TRAFFIC ENGINEERING AND OPERATIONS BULLETIN 19-03
ROADWAY DESIGN BULLETIN 19-03
PROGRAM MANAGEMENT BULLETIN 19-03
CONSTRUCTION BULLETIN 19-01

DATE: July 3, 2019

SUBJECT: **Wrong-way Driving Advanced Countermeasures at Interchange Exit Ramps**

LAST REVISION 11/ /19	DESCRIPTION: Added Roadside Sign Assembly-7	FY 2019-20 STANDARD PLANS	ENHANCED HIGHWAY SIGNING ASSEMBLIES	INDEX 700-120	SHEET 2 of 10
--------------------------	--	------------------------------	-------------------------------------	------------------	------------------

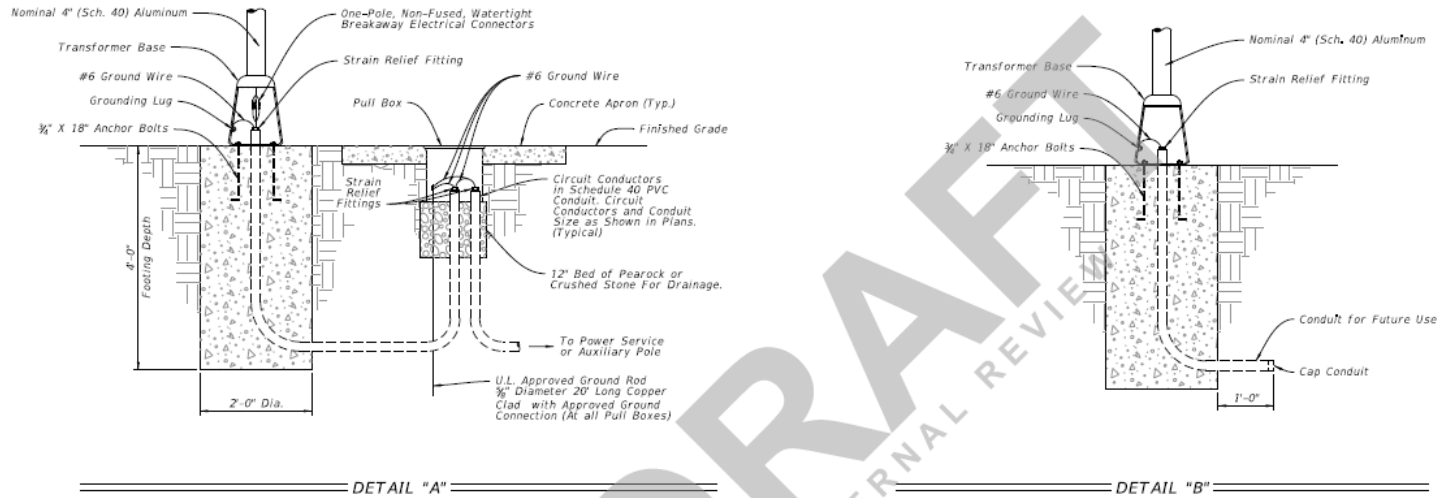
1. The following *FY 2019-20 Standard Plans Interim Revision (IR)* is released:

Standard Plans Interim Revision, [Index IR700-120-01](#) (Enhanced Highway Signing Assemblies, Roadside Assembly-7)

2. Sheets 1, 2, and 9 of *Index IR700-120-01* are shown in Attachment 'A'.

ROADSIDE SIGN ASSEMBLY-7

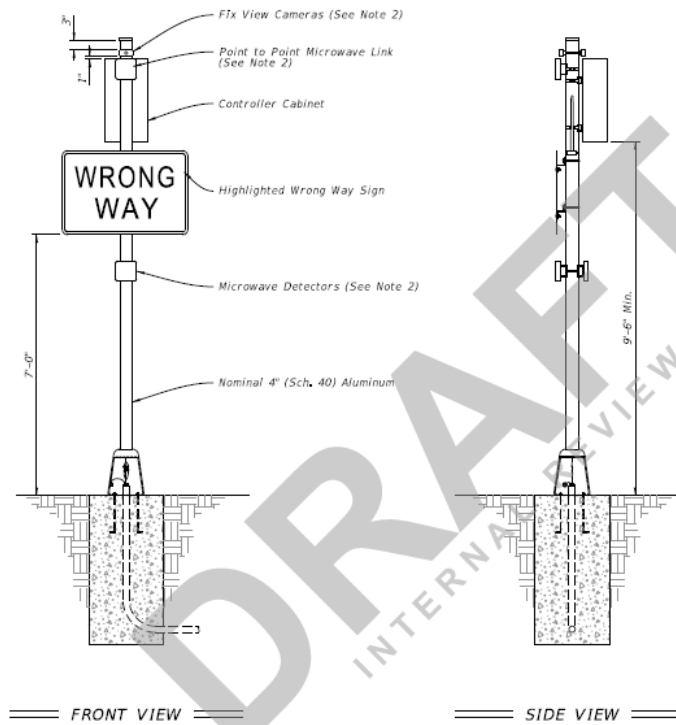
- NOTES:**
1. Type A7 Assembly (Conventionally-Powered) is shown. Type B7 Assemblies (Solar-Powered) Similar.
 2. Install cameras, point to point microwave link, microwave detectors, and antennas in accordance with the manufacturer's instructions.

ATTACHMENT 'B'

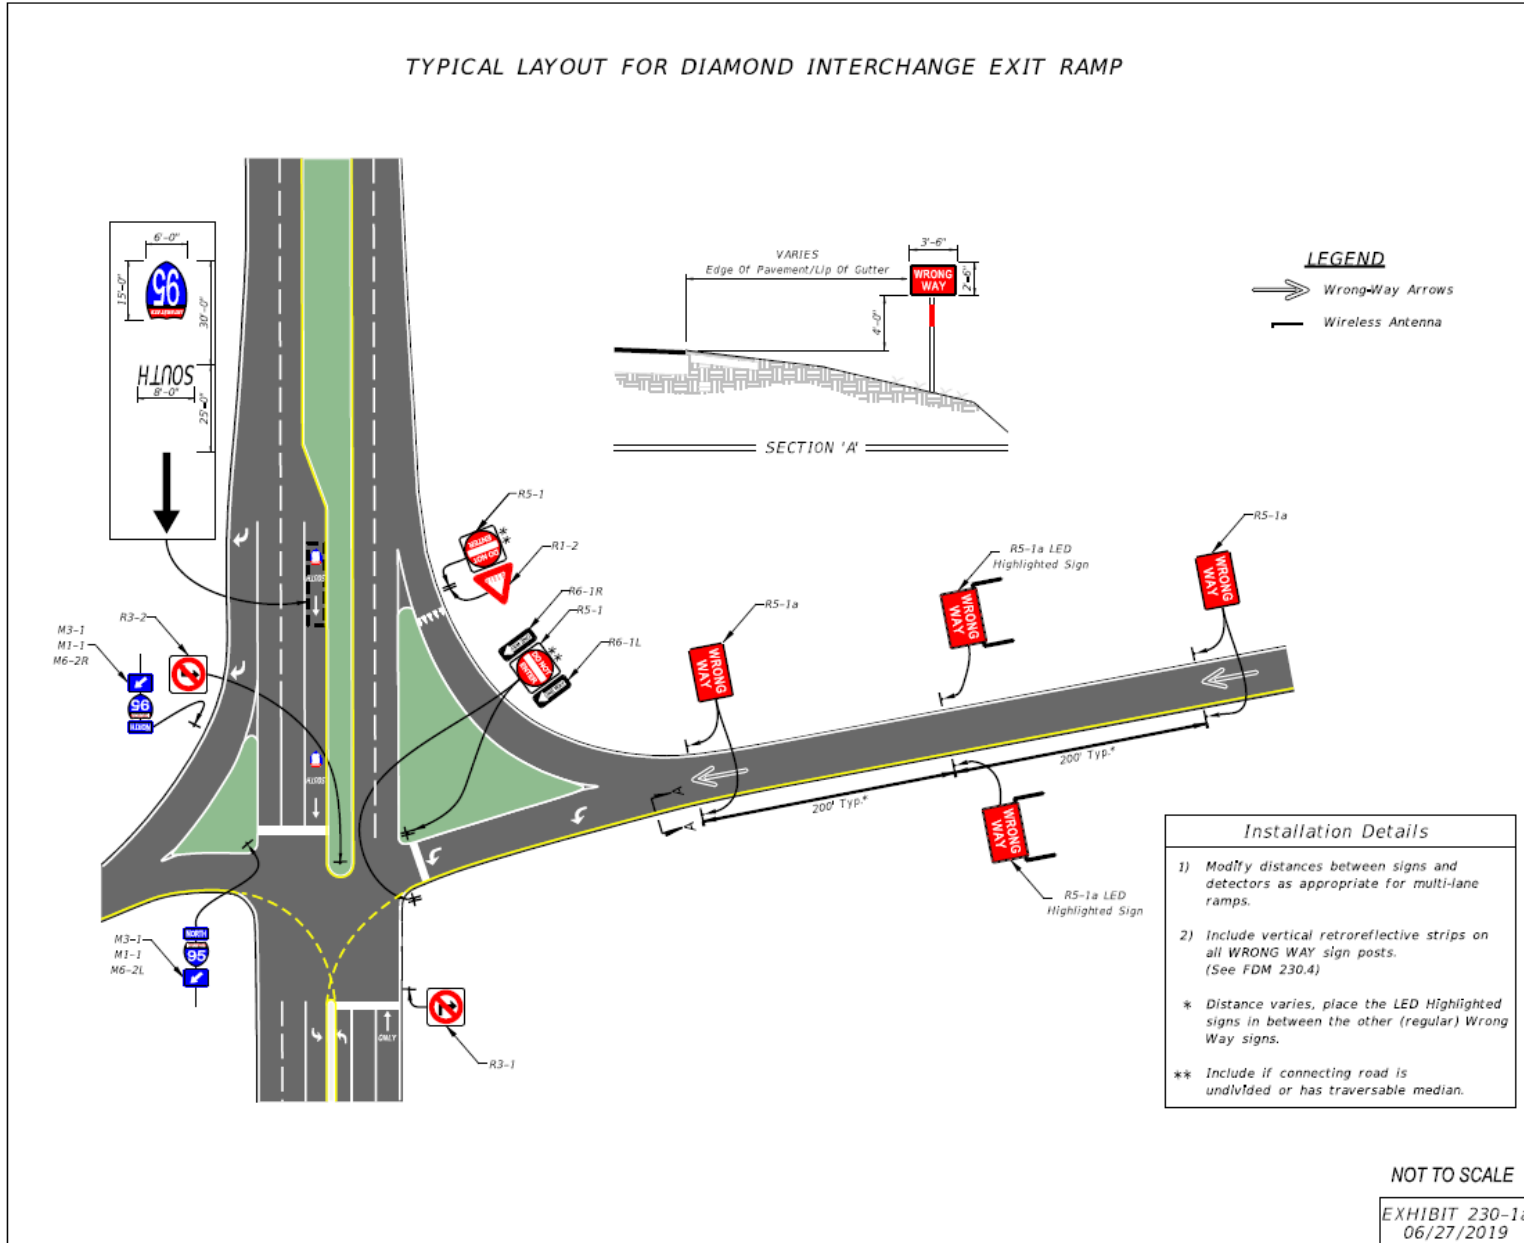
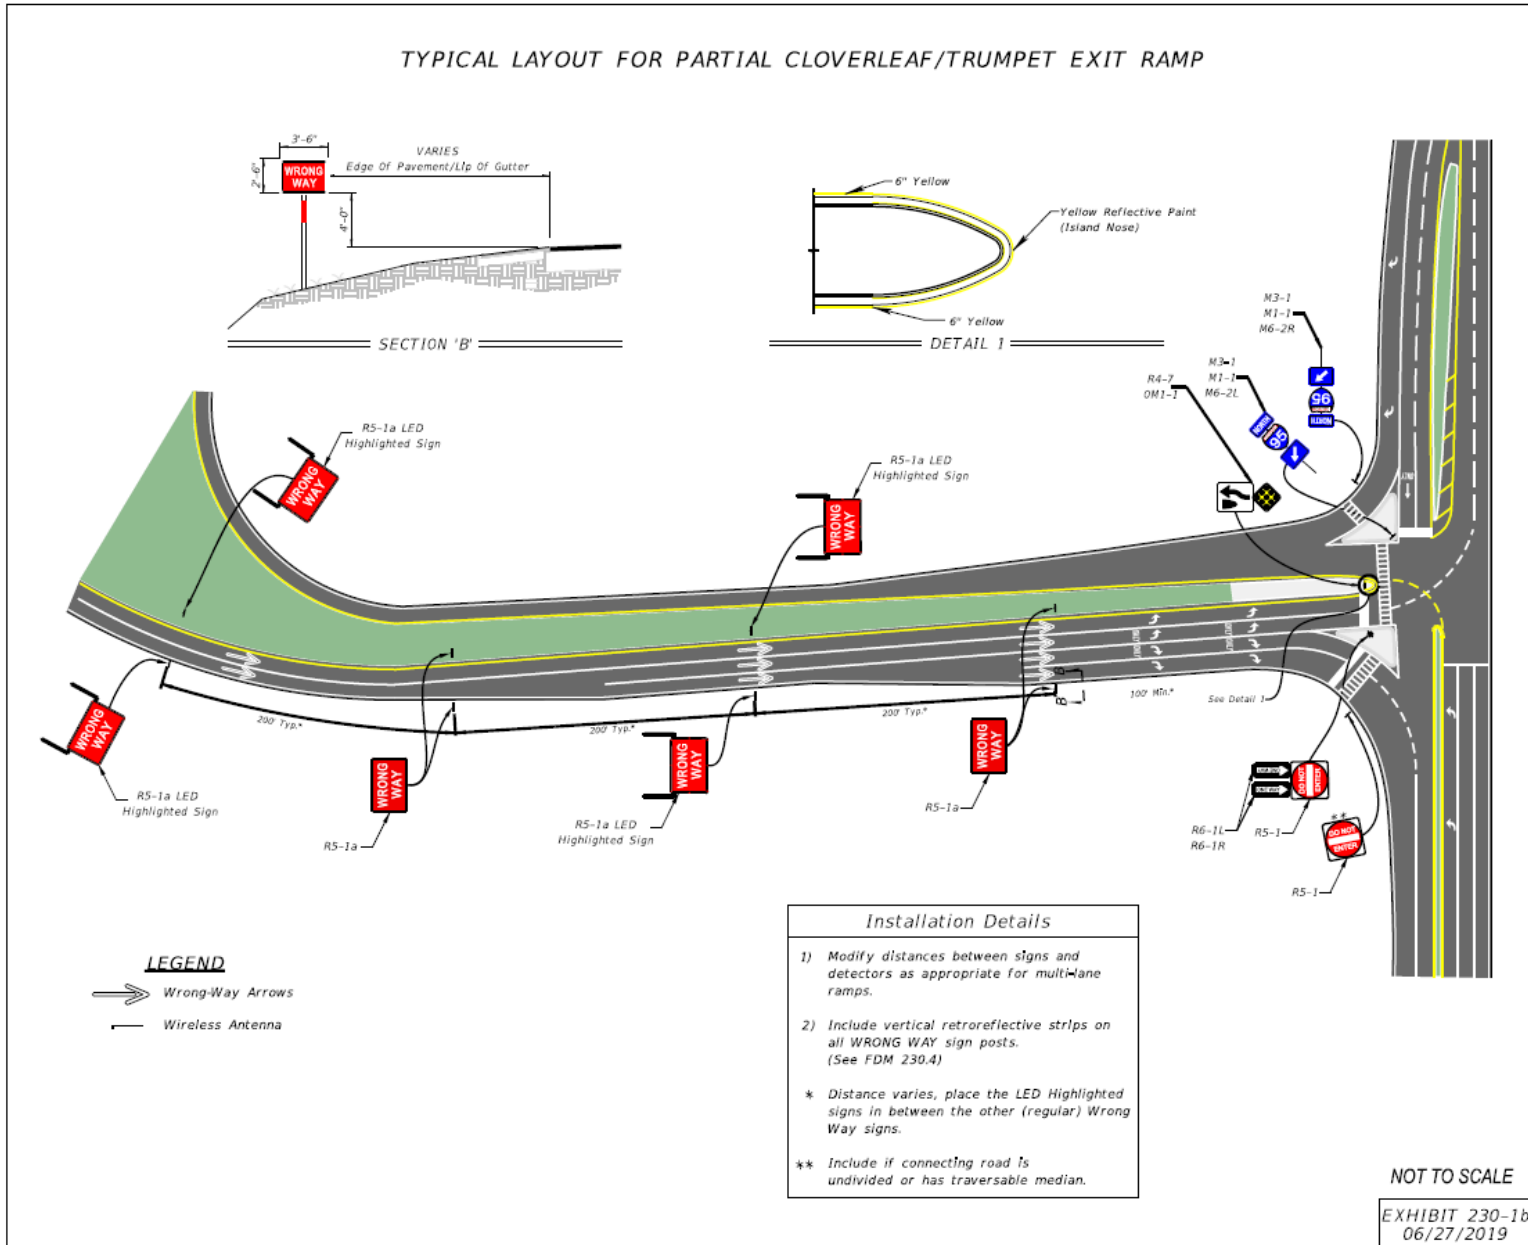
The standard for signing and pavement marking and advanced countermeasure installation at exit ramp intersections are illustrated in Exhibit 230-1a and 230-1b. The description of the layouts are as follows:

- 1) Include MUTCD “optional” signs; second DO NOT ENTER, second WRONG WAY sign, and ONE WAY signs.
- 2) Include NO RIGHT TURN and NO LEFT TURN signs.
- 3) Use 3.5 feet by 2.5 feet WRONG WAY signs mounted at four-foot height and include a retroreflective strip on sign supports.

- 4) Include 2-4 dotted guide line striping for left turns between ramps entrances/exits and cross-streets.
- 5) Include retroreflective yellow paint on ramp median nose where applicable.

- 6) Include a straight arrow and route shield pavement marking in left-turn lanes extending from the far-side ramp intersection through the near-side ramp intersection to prevent premature left turns. Refer to TEM, Section 4.2.4 “Route Shields for Wrong Way Treatment” for additional information.

- 7) Include a straight arrow and ONLY pavement message in outside lane approaching the ramp exit.
- 8) Install a pair of Light-emitting Diode (LED) Highlighted Wrong-Way Signs. For long ramps or for ramps with limited sight distance, two sets of the pairs of Highlighted Signs may be used, as illustrated in ***Exhibits 230-1a*** and ***230-1b***. The Highlighted Sign assembly may be powered by either solar or line power. If line power is used, include the power service assembly and conduit and cable from the Highlighted Sign to the service point. The Highlighted Sign shall be integrated back to the District’s Traffic Management Center (TMC). Connectivity between the Highlighted Sign and the TMC may be provided by either fiber optic or wireless communications. If fiber optic communications are used, include the fiber optic cable, conduit, and transmission equipment. If wireless communications are used, include the antenna and transmission equipment.

2. Replace ***FDM Exhibit 230-1*** with the corresponding exhibits in Attachment ‘B’.

Figure 7.2.1 Typical Layout for Diamond Interchange Exit Ramp

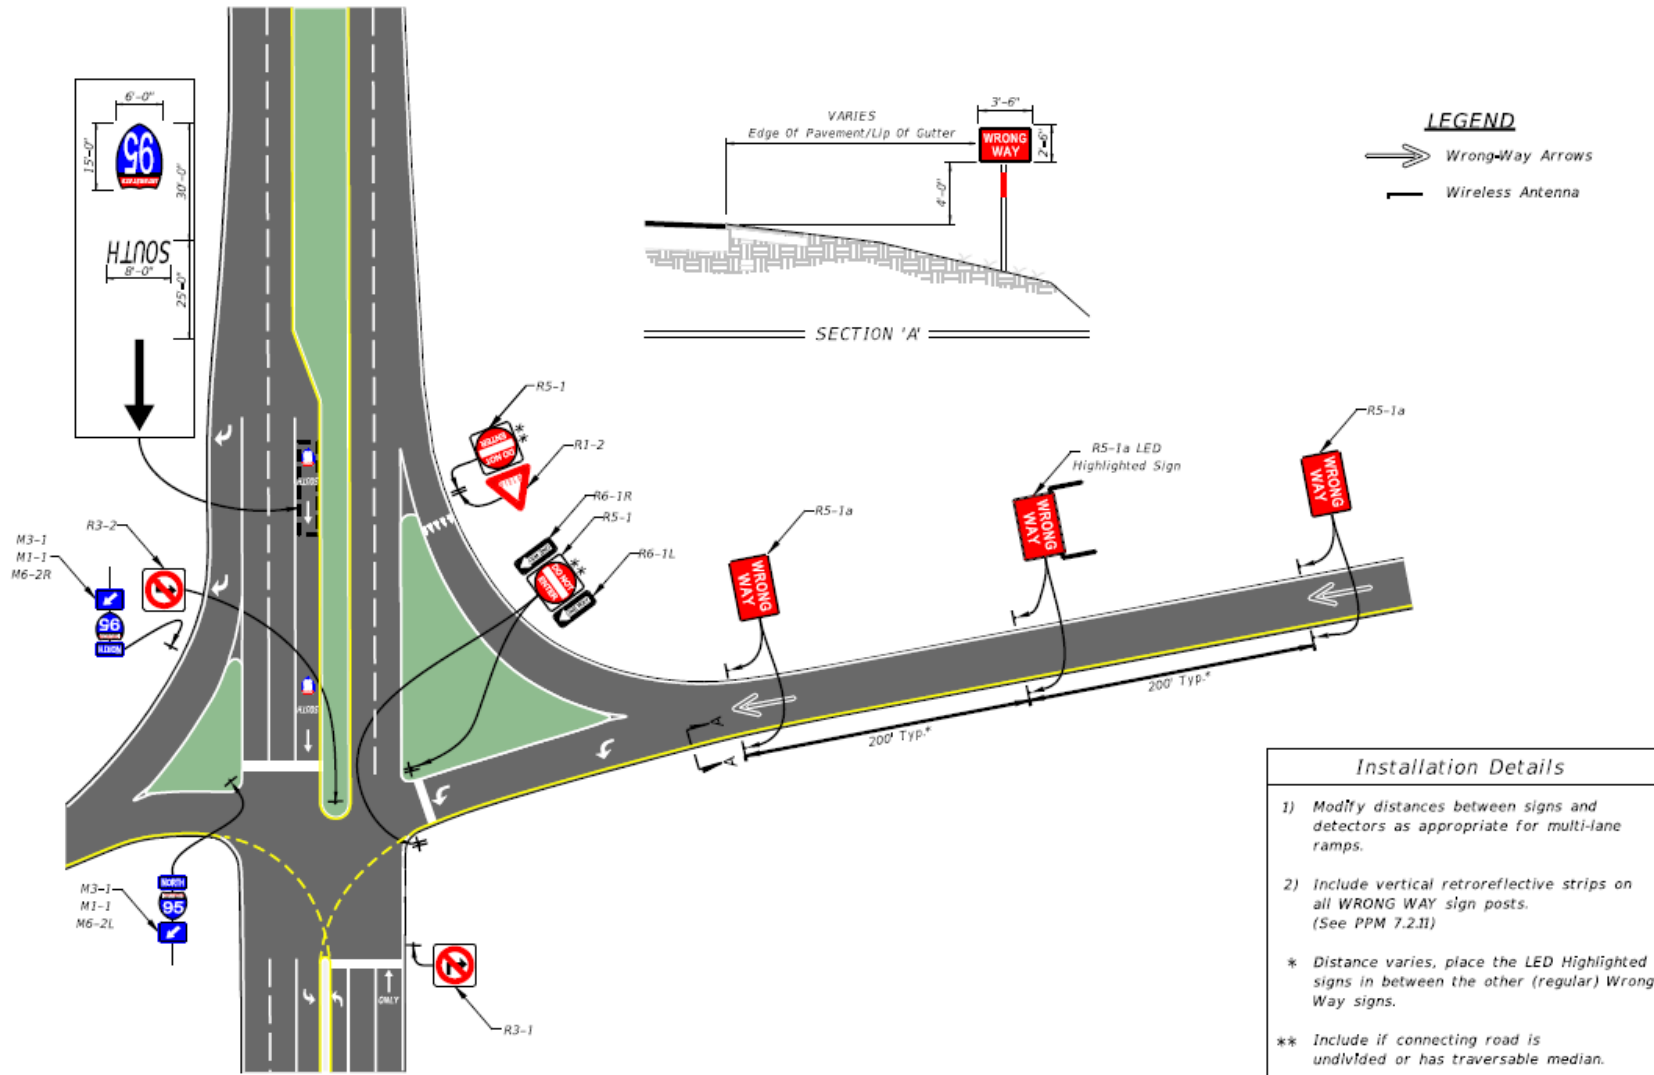
The standard for signing and pavement marking and advanced countermeasure installation at exit ramp intersections are illustrated in Figures 7.2.1 and 7.2.2. The description of the layouts are as follows:

- 1) Include MUTCD “optional” signs; second DO NOT ENTER, second WRONG WAY sign, and ONE WAY signs.
- 2) Include NO RIGHT TURN and NO LEFT TURN signs.
- 3) Use 3.5 feet by 2.5 feet WRONG WAY signs mounted at four-foot height and include a retroreflective strip on sign supports.

- 4) Include 2-4 dotted guide line striping for left turns between ramps entrances/exits and cross-streets.
- 5) Include retroreflective yellow paint on ramp median nose where applicable.

- 6) Include a straight arrow and interstate shield pavement marking in left-turn lanes extending from the far-side ramp intersection through the near-side ramp intersection to prevent premature left turns. Refer to TEM, Section 4.2.4 “Route Shields for Wrong Way Treatment” for additional information.

- 7) Include a straight arrow and ONLY pavement message in outside lane approaching the ramp exit.
- 8) Install a pair of Light-emitting Diode (LED) Highlighted Wrong-Way Signs. For long ramps or for ramps with limited sight distance, two sets of the pairs of Highlighted Signs may be used, as illustrated in **Figures 7.2.1** and **7.2.2**. The Highlighted Sign assembly may be powered by either solar or line power. If line power is used, include the power service assembly and conduit and cable from the Highlighted Sign to the service point. The Highlighted Sign shall be integrated back to the District’s Traffic Management Center (TMC). Connectivity between the Highlighted Sign and the TMC may be provided by either fiber optic or wireless communications. If fiber optic communications are used, include the fiber optic cable, conduit, and transmission equipment. If wireless communications are used, include the antenna and transmission equipment.

2. Replace *PPM Figures 7.2.1* and *7.2.2* with the corresponding figures in Attachment ‘C’.
